Re: Addendum to Engineering Design Report
Shore Terminals Tacoma Facility
Tacoma, Washington
1074-01

This letter presents an Addendum to the Engineering Design Report for the Shore Terminals Tacoma Facility, dated February 20, 2006. The Addendum has been prepared in response to a verbal request by the Washington State Department of Ecology (Ecology) for additional monitoring wells in one area of the facility to assist in monitoring the proposed remedial system. Ecology requested that 3 to 4 additional wells be installed in Area 1 prior to implementation of the proposed *in-situ* bioremediation program in this area to better define the extent of dissolved-phase benzene. In an email dated March 29, 2006, Ash Creek Associates, on behalf of the Involved Parties, proposed the installation and monitoring of three groundwater monitoring wells within Area 1 to address this request. Ecology accepted the proposed number and location of the wells in a March 30, 2006 email to Ash Creek Associates (copies of the email correspondence are included as Attachment A for reference). This addendum provides the methods and procedures to be used to install the proposed monitoring wells. Methods for gro

Figure 1 – Locations of Proposed Monitoring Well Installations
Attachment A – Correspondence with Ecology

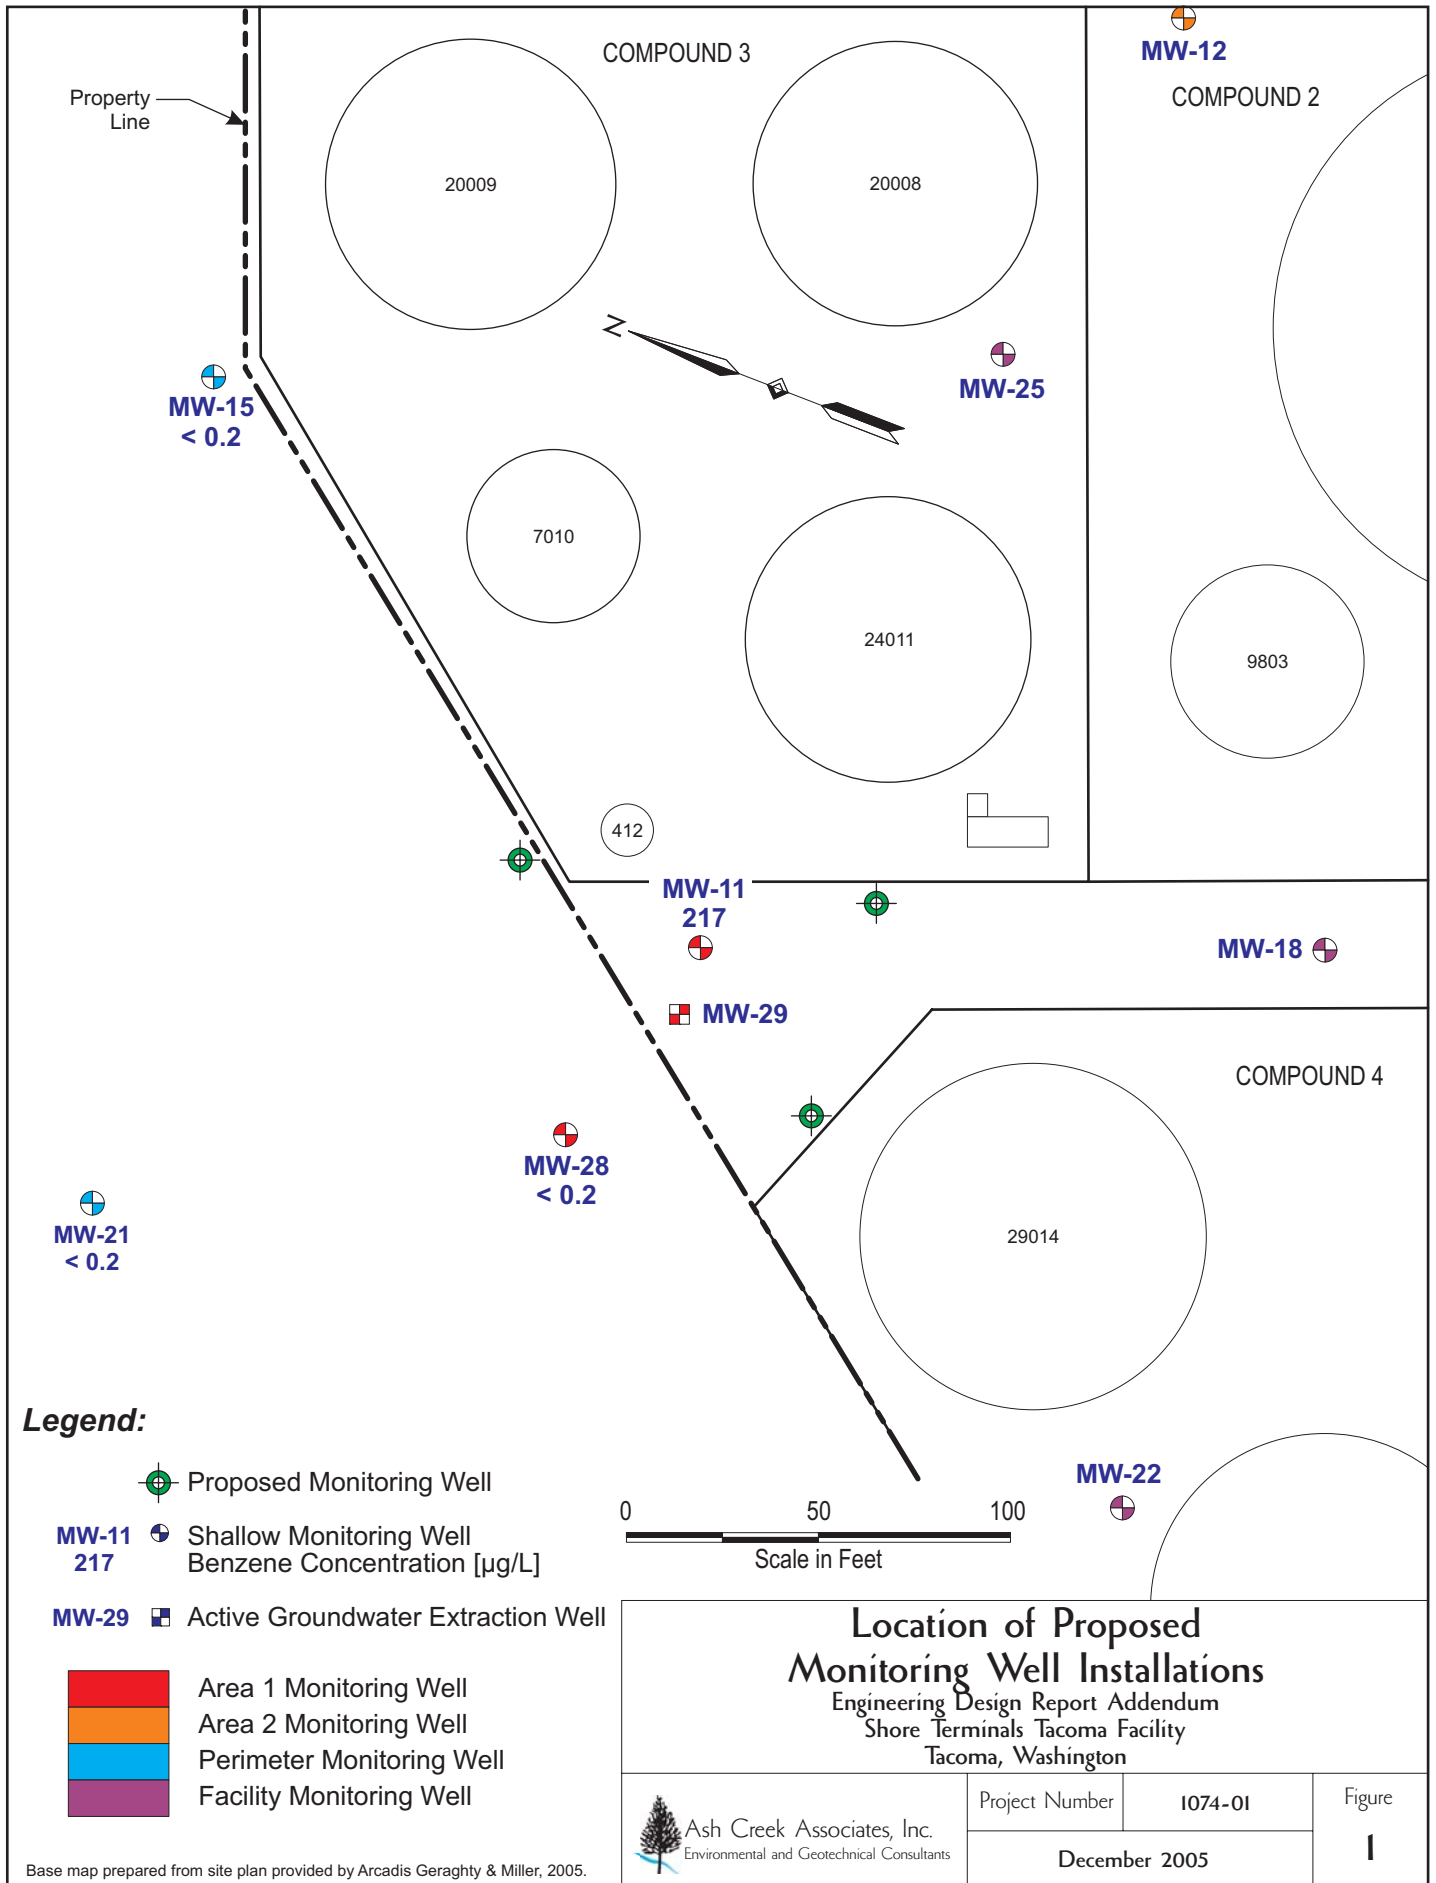
Well Locations. The locations of the three proposed monitoring wells are shown on Figure 1, consistent with communications between Ash Creek and Ecology.

Hi Dom - In followup to our conversation today, attached is a map showing the proposed locations of the three wells (in red), overlain over the Ecology proposed locations. Let me know if these locations would be acceptable to Ecology.

Amanda, Your proposed well locations should be fine. Please include those in the Area 1 remediation plan. We thank you and your clients for working this through. Dom Reale
